CBD & SOUTH EAST LIGHT RAIL PROJECT

(RANDWICK CITY COUNCIL & UNSW AREA)

TECHNICAL REVIEW – TRAFFIC ENGINEERING & ROAD SAFETY (DECEMBER 2013)

Figure 14: Anzac Parade (UNSW) – Proposed Conditions

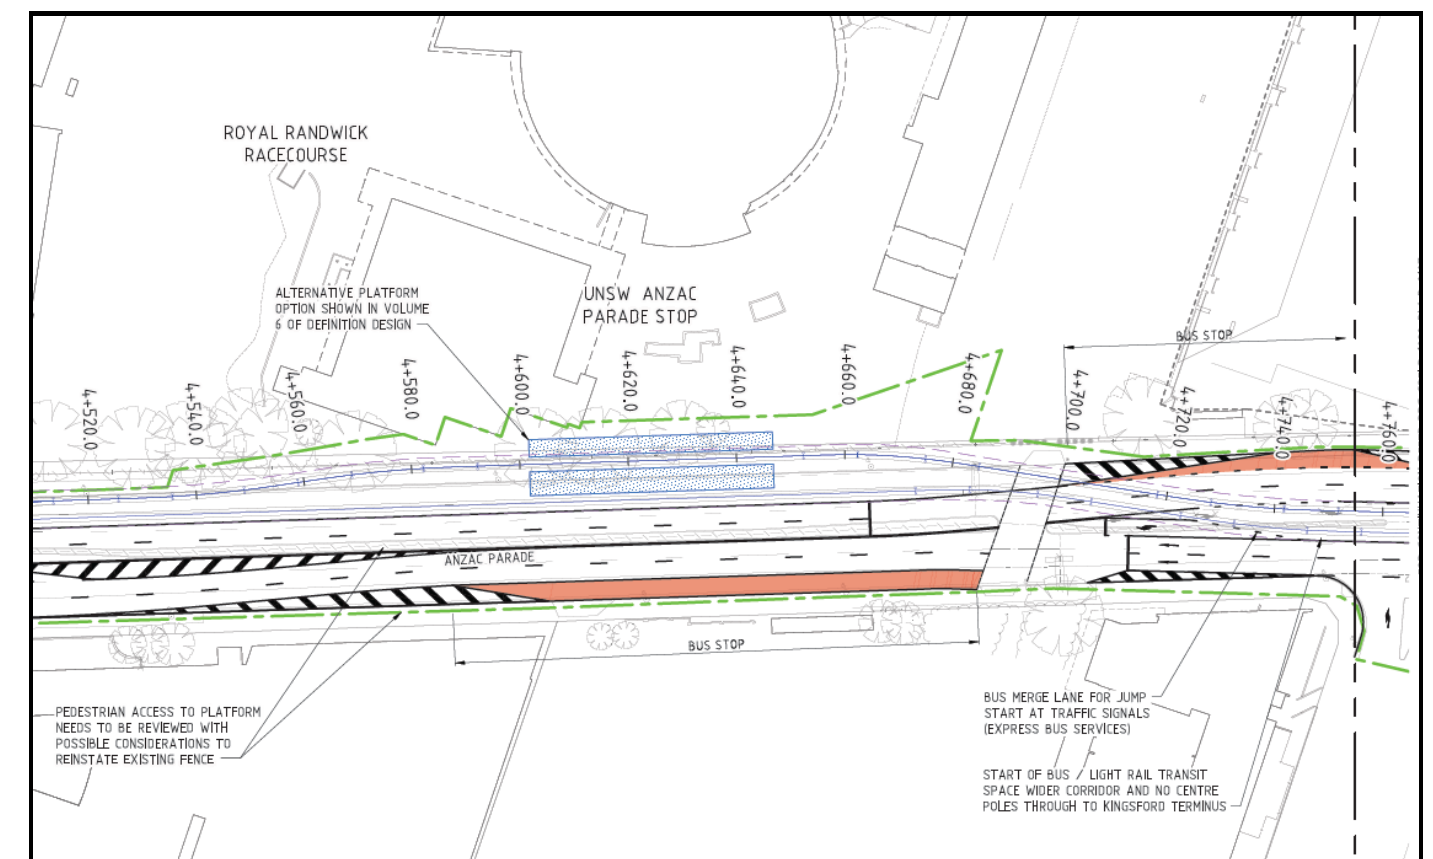
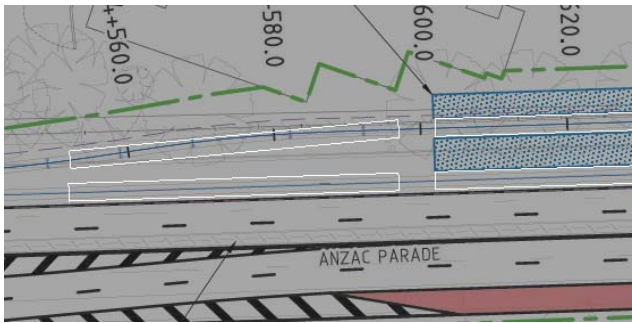
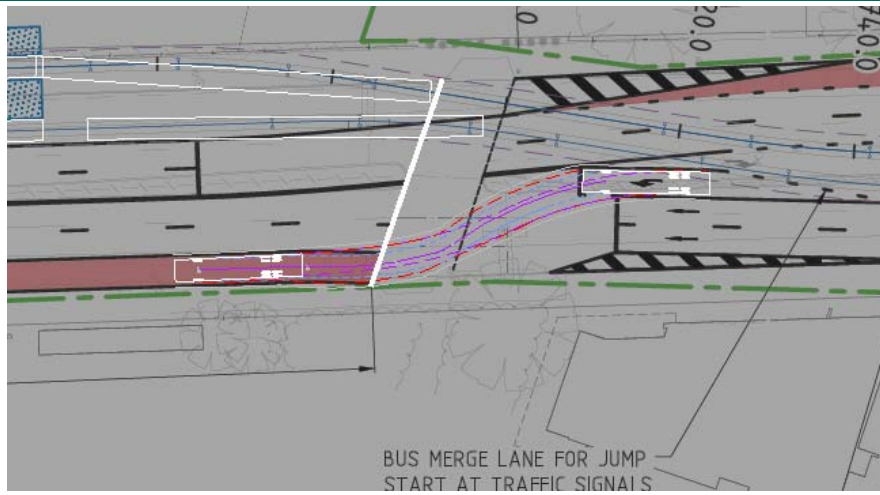
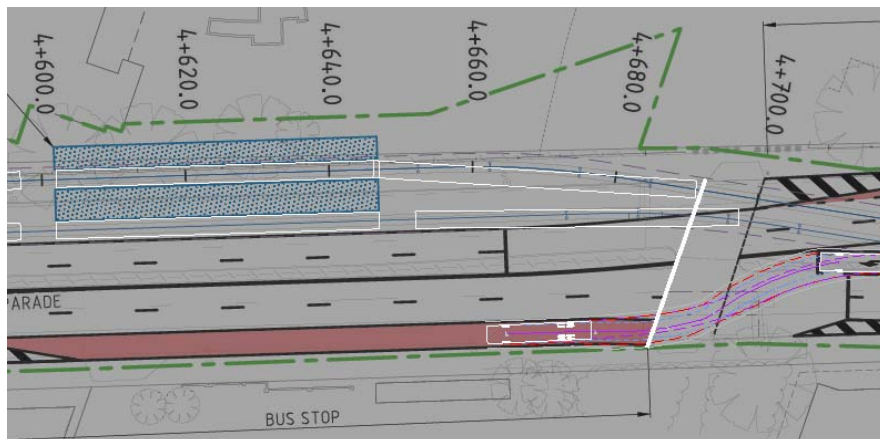
Platform Size	Side platform 45.0m x 3.2m = 144.0 sqm. Island platform 45.0m x 4.4m = 198.0 sqm. The report indicates the need to make provision for future lengthening of stops, but there is not sufficient room at the northern end.	Assumption: LRV at 2-3 minute frequencies at CBD end will result in LRV at 4-6 minute frequencies at this location. Assume approximately 3 LRV each 15 minute period. Alighting: Assuming a capacity of 300 pax per LRV, should be no more than 300 pax alighting at any one time. Capacity of platforms to cater for peak alighting numbers (approx. 898 pax in 15 minute period). Using the Fruin Level of Service criteria, the ramp (average flow rate of 60 pax per minute) is expected to operate with a Level of Service of A. However, if 299 pax alighted from one LRV, the Level of Service would drop to E. Boarding: Capacity of platforms to cater for peak boarding numbers (approx. 1,143 pax in 15 minute period). Using the Fruin Level of Service criteria, this platform is expected to operate with a Level of Service of E (381 pax	Alighting: Proposed southbound platform ramp will lead directly to footpath and will not restrict flow off the stop (subject to proposed fencing arrangements to separate stop from shared path). Congestion may encourage some passengers to use northern pedestrian access. Boarding: Proposed citybound platform will be very congested (Level of Service E/F) with some pax being required to wait on ramp and approaches. The short ramp and limited storage area on the crossing may prevent all passengers being able to access the platform stop at peak times. This will prevent

Category	Sub-Category	Proposed Conditions	Issue / Comment	Potential Alternative / Mitigating Measure
			<p>waiting for LRV).</p> <p>The ramp (average flow rate of 76 pax per minute) is expected to operate with a Level of Service of E.</p> <p>One example of a large centre island platform stop in Melbourne is the Melbourne University stop. This is approximately 6.5m wide and 60m long with ramps and signalised pedestrian crossings at both ends.</p> 	<p>safe passenger circulation along the stop.</p> <p>Design track layouts to provide for future lengthening of citybound stop.</p> 
	Storage	Ramps provided at both north and south ends to provide access.	The short ramp and limited storage area on the crossing to the citybound stop may prevent all passengers being able to access the platform stop at peak times. This will prevent safe passenger circulation along the stop.	Review size of platform stop and length of ramp to cater for peak passenger loads.

Swept Paths	Nil.	LRV and buses will create wider swept paths as they undertaken turns to and from the centre of the road.	Review swept paths of turning LRV and buses.

LRV	<p>LRV Priority crossings at both ends of stops. University Mall Pedestrian Operated Signals located approximately 30m south of southern stop crossing.</p> <p>NB: Stop line for Pedestrian Operated Signals should be located 6m back from crosswalk.</p>	<p>Southbound LRV will need to 'trigger' LRV phase to cross back to centre of road. There is not enough length between stop and Pedestrian Operated Signals for LRV to store without blocking southern crossing.</p> <p>A second northbound LRV could follow another LRV through the Pedestrian Operated Signals as there is just enough room for it to store clear of the Pedestrian Operated Signals. However, the second northbound LRV would reduce visibility to pedestrians using the Pedestrian Operated Signals.</p> 	<p>Review how southbound LRV will 'trigger' tram phase.</p> <p>Review storage of southbound LRV between stop and POS.</p> <p>Review storage of northbound LRV between stop and POS.</p>

Signal Pedestals	There is no room between either the two directions of traffic or between the southbound traffic lanes and the northbound light rail tracks.	<p>There is no room available for signal pedestals to be located next to the southbound traffic. Large mast arms will be required. The height and location of the large mast arms will need to consider the overhead light rail wires.</p> <p>The complex movements required at the intersection of the Pedestrian Operated Signals would also benefit from adjacent signal pedestals. However, large mast arms are likely to be required.</p>	Review layout to create space for signal pedestals
	Crossing Points	LRV priority crossings are shown at the north and south ends of the stops.	<p>As shown on the Stop Plan, the crossings do not need to extend on to the northern Light rail tracks.</p> <p>Access at the northern end is important if land use within UNSW changes and provides an alternative access/egress to the stop during peak times.</p> <p>LRV Priority Pedestrian Crossings are proposed. In Melbourne, the signs used in these instances are 'Give Way to Trams'. With the high number of pedestrians and complex movements for the LRV, static signs may not be enough. Could consider supplementary LRV-activated LED signs to warn of approaching LRV.</p> <p>Important to used different materials to indicate LRV areas and pedestrian waiting areas.</p>	Remove crossings across northbound tracks. Install a fence along the east side of the northbound tracks.

Ramps	DDA compliant ramps provided at both north and south ends to provide access.	The ramp ends at the crossing points which may create congestion as pedestrians wait to cross the southbound track.	Shorten ramps if possible to create larger waiting areas.
Access	Illegal Access	No pedestrian fencing shown.	Existing pedestrian fence is located in the centre median adjacent to the Pedestrian Operated Signals. Illegal pedestrian movements to and from the platform stops is likely.	Consider the installation of pedestrian fencing adjacent to the citybound LRV track.
	Safety	-	Illegal access is the main safety issue as discussed above.	Nil.
	Footpath / Shared Path	Wide footpath to be provided along east side of tracks.	Footpath along east side of Anzac Parade used as a bicycle route.	Consider barrier along outside of side platform to prevent people from just walking out on to shared path and creating

Category	Sub-Category	Proposed Conditions	Issue / Comment	Potential Alternative / Mitigating Measure
				pedestrian/cyclist conflict.
	Vehicle	-	n/a	n/a
	Sharing of Tracks	Buses to share LRV track south of this location.	Bus movements out of LRV corridor provided through a jump start lane. There is no separation between the bus lane and the adjacent traffic lanes. It is desirable to create an island between the bus lane and the adjacent traffic lanes to ensure drivers do not move off when the bus moves off (as the bus needs to cut in front of the traffic). A bus storing in this lane may be unable to store clear of the light rail tracks and may block the tracks. It is unclear how southbound buses get on to light rail tracks.	Review layout of bus jump start lane to create separation between bus lane and adjacent traffic lanes. Review how southbound buses get on to light rail tracks.
	Bus Stops	Existing northbound bus stops (80m) retained. Provision for one southbound bus stop (15m).	Nil.	Nil.

Intermodal	Bus / LRV Transfer	-	Adjacent bus stops are expected to be for local bus routes. Unlikely to be high number of transfers.	Nil.
	Bus Priority	-	As above.	Nil.
Signal Operation	Overview	Complex intersection at Pedestrian Operated Signals to cater for all movements.	Multiple phases will be required – LRV phase, pedestrian phase, northbound bus phase (which could run with tram phase or SB traffic) and a traffic phase. A road safety risk is that when pedestrians see traffic come to a stop (particularly those pedestrians on the west side of Anzac Parade), they may assume that the pedestrian phase may run next. However, the bus or LRV phases may run and create a conflict with pedestrians. 	Review the potential phasing arrangement to minimise conflicts.
	LRV Movements	LRV to cross to and from centre of Anzac Parade, through Pedestrian Operated Signals.	As outlined above, LRV will be delayed moving to and from the centre of the road and the storage of LRV whilst waiting to move through intersection may block crossings.	Nil.

Bus Movements	Buses to share LRV track south of this location.	Citybound buses waiting to merge across could delay LRV, run bus clearance phase at same time as LRV phase. Ideally would be some separation between citybound bus and northbound vehicles.	Review layout to create separation between northbound buses and northbound traffic.
	Pedestrian Movements	Pedestrian Operated Signals crossing approximately 23m wide across Anzac Parade.	If a LRV or bus is detected, the pedestrian phase will take the longest to 'close down' (to ensure adequate clearance time for pedestrians to complete their crossing).	Consider PUFFIN at Pedestrian Operated Signals.
	Traffic Impacts	Complex intersections at High Street and University Mall will increase delays to other traffic.	No right turn proposed in to Day Avenue. It is understood that this is a key local route through this area and more suitable than Barker Street. Keeping tracks on east side of Anzac Parade may permit right turn into Day Avenue to be retained.	Review layout of University Mall Pedestrian Operated Signals and Day Avenue traffic movements.

Figure 21: Kingsford Terminus – Proposed Conditions

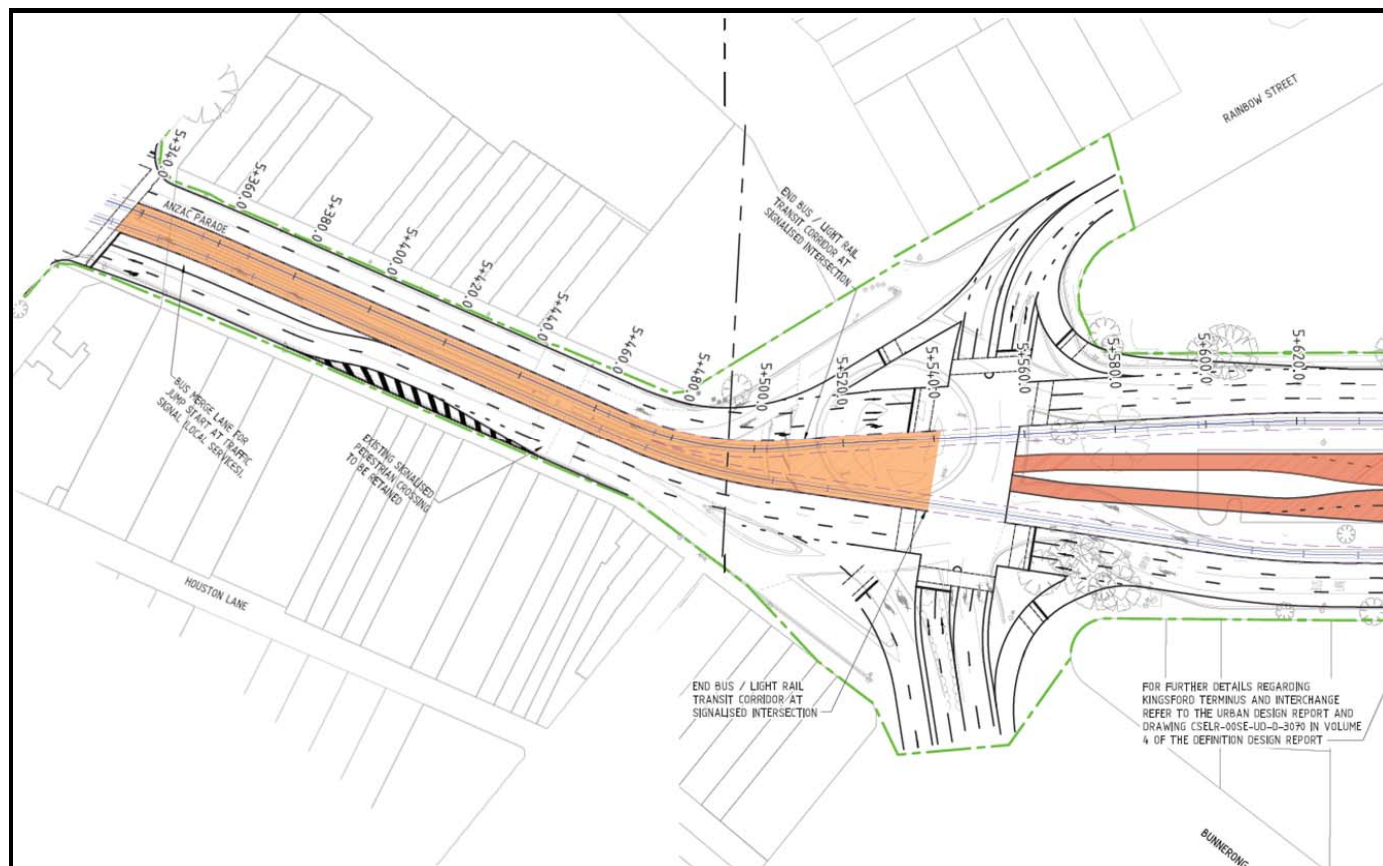
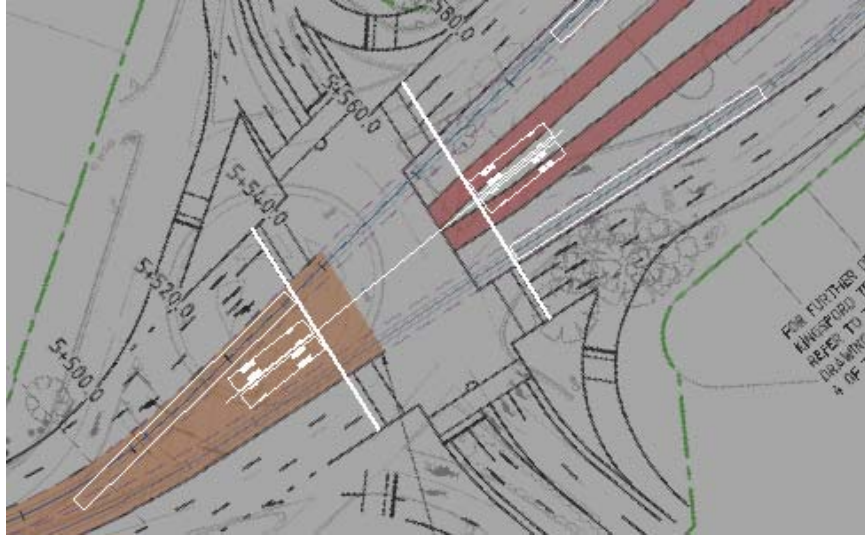
Category	Sub-Category	Proposed Conditions	Issue / Comment	Potential Alternative / Mitigating Measure
Consistency	-	-	The 'Road Engineering' plans and the 'Stop Plans' show different configurations for the pedestrian crossings. It has been assumed that the Stop Plans are the basis for comment.	Update plans to be consistent.
Location	Surrounding Land Uses	Intermodal transfer stop.	Stop will be a major intermodal transfer stop with a predicted low number of 'walk up' passengers. Terminus could be located further south to reduce the loss of car parks within the central median.	Nil.
	Land Acquisition	Car park to east of Anzac Parade.	If used as a Park and Ride location, need to consider how passengers access the stop.	Review passenger access from Park and Ride area to stop.
Layout	Platform Size	Both island platforms 45.0m x 6.0m = 270 sqm.	Precinct Access Plan (Table 7-18) states: 1,454 boardings & 515 alightings forecast for 2021 (total – 1,969). 1,851 boardings & 615 alightings forecast for 2036 (total – 2,466). Platform stops easily able to accommodate pax numbers.	Nil.

Storage	Stops have been designed to facilitate predicted high number of transfers.	Nil.	Nil.
	Swept Paths	-	The swept paths for LRV and buses will increase on the track curves to and from the terminus.	Need to ensure all roadside furniture, stop lines and pedestrian storage areas are setback to cater for the increased clearance requirements.
	LRV	-	There is sufficient length for second southbound LRV to cross intersection and wait before entering stop. Room for one northbound LRV to store within the terminus and another one waiting at the Nineways intersection. However, no room for additional LRV to store outside of the terminus waiting to enter (northbound) as it will block the bus entry and potentially the pedestrian access. 	Review layout to reduce risk of additional LRV blocking the bus and pedestrian access.

Category	Sub-Category	Proposed Conditions	Issue / Comment	Potential Alternative / Mitigating Measure
	Signal Pedestals	-	Signal pedestals may be required if bus / LRV interaction is to be controlled.	Review how signal control will be provided.
	Traffic Lanes	3 lanes in both directions.	Nil.	Nil.
	Parking Lane	-	It is assumed that some on road parking will continue to be provided.	Nil.
Access	Crossing Points	Access to stop from Nineways intersection and Pedestrian Operated Signals.	<p>The Wallace Street Pedestrian Operated Signals are located too close to the Wallace Street intersection e.g. left turners from Wallace Street may not see signals. Also, stop line for Pedestrian Operated Signals should be 6m back from crosswalk.</p> <p>It is unclear if the South Juniors Pedestrian Operated Signals remain. Some pedestrians may use this location to access the central median to walk to the stop. Also, if centre median parking is retained, there may be a number of pedestrians who walk along the centre median to reach the stop. No footpaths are shown in the central median.</p> <p>There is no storage between the traffic lanes and the light rail tracks for pedestrians. In addition, they also have to get across the bus lanes. Different crossing locations are proposed on different plans. On the Stop Plans, the pedestrian crossing point is located very close to the southbound bus stop, which may reduce visibility to pedestrians using the crossing.</p>	<p>Review layout of Wallace Street Pedestrian Operated Signals, including signalisation of the Wallace Street left turn (amber / red when crossing activated, Give Way at other times).</p> <p>Review layout of central median and accommodate pedestrian movements if required.</p> <p>Review layout of pedestrian crossings across the traffic lanes, and within the stop area.</p>

Ramps	Back to back ramps at each end to provide transfers.	Back to back ramps required due to level differences. The number of transfers between stops is expected to be low. At the northern end, it is expected that most pedestrians will choose which stop to access from the Nineways intersection. The location of bicycle storage cages will also influence the use of the ramps.	Nil.
	Illegal Access	-	There is the potential for illegal access along Anzac Parade between Nineways and the Pedestrian Operated Signals, how this expected to be relatively low.	Consider the provision of fencing between the traffic lanes and the light rail tracks.
	Safety	-	Illegal access is the main safety issue as discussed above.	Nil.
	Footpath / Shared Path		Nil.	
	Vehicle	Central median break opposite Wallace Street to be closed.	<p>The Wallace Street intersection could be reconfigured as only left in and left out movements will be permitted. A traffic island could be installed or the intersection realigned to reduce vehicle entry speeds from Anzac Parade. Pedestrian movements across this intersection may increase from the car park to the west of Anzac Parade to the stop access immediately south of Wallace Street.</p> <p>One of the reports indicates that a Kiss and Ride area should be created – this is supported as otherwise kiss and ride activities will occur throughout the area. This is not shown on the plans. The location of the Kiss and Ride area should be close to the stops and close to a signalised crossing point if located on the left hand side of the road.</p>	<p>Review layout of Wallace Street intersection.</p> <p>Review provision of Kiss and Ride area.</p>

Intermodal	Sharing of Tracks	LRV and buses will share tracks north of the Nineways intersection.	As discussed above, unclear how LRV and bus movements will be controlled across Nineways intersection.	Review control of LRV and bus interaction.
	Bus Stops	-	It is unclear if bus stops on Anzac Parade will be retained. If so, they will only be for local services. Access from the bus stops to the LRV stops needs to be considered.	Review access between local bus stops and LRV stops.
	Bus / LRV Transfer	-	Stop will be a major intermodal transfer stop with a predicted low number of 'walk up' passengers.	Nil.
	Bus Priority	-	As discussed above, unclear how LRV and bus movements will be controlled within terminus area.	Review control of LRV and bus interaction.
Signal Operation	Overview	-	There will be some interaction between buses and other traffic when southbound buses exit the stop back on to Anzac Parade.	Nil.

LRV Movements	-	n/a	n/a
	Bus Movements	-	<p>There is no provision for bus entry and exit for local buses between stop and Nineways to remove buses from Nineways intersection. Future provision for these movements should be provided so that any route changes, or the removal of the buses from the light rail tracks further north, could be accommodated.</p> <p>Bus movements exiting the stop will require southbound traffic on Anzac Parade to be stopped. The Pedestrian Operated Signals near Wallace Street could be used</p>	<p>Review layout to make provision for bus entry and exit movements to the north of the stop but south of the Nineways intersection.</p> <p>Review control of southbound bus movements exiting the stop.</p>
	Pedestrian	Inconsistency between Road Engineering and	The plans appear to show signalised crossings of bus and light rail tracks. However, it is unlikely that pedestrians will obey the signals. LRV or bus priority crossings are expected to be more suitable to this	Review control of pedestrian crossings.

Category	Sub-Category	Proposed Conditions	Issue / Comment	Potential Alternative / Mitigating Measure
	Movements	Stop Plans.	environment, subject to the control of LRV and bus conflicts.	
	Traffic Impacts	-	Expected to be minimal traffic impacts. Wallace Street Pedestrian Operated Signals could be linked to Nineways intersection located approximately 150m to the north.	Review linking of Pedestrian Operated Signals.
